AN/PRC-112...

# PROBLEMS GET FIXED

**NEWSFLASH!  
...THIS JUST IN...  
FREE UPGRADES  
BEING GIVEN TO  
AN/PRC-112  
RADIOS!!**

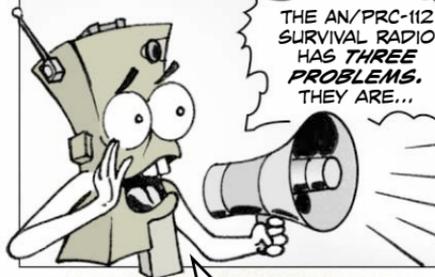
1. The large VOL/OFF knob can accidentally be turned on when the radio is handled. If turned on and left on, it drains the battery.
2. Water seeps into the radio's case.
3. Frequency hopping happens by chance due to the design of the radio's transponder.

1. Current VOL/OFF knob is replaced with a smaller knob that is more difficult to accidentally turn on.

2. A new, better gasket that stops water intrusion is installed in the lid of the case.

3. A more efficient transponder is added that corrects chance frequency hopping.
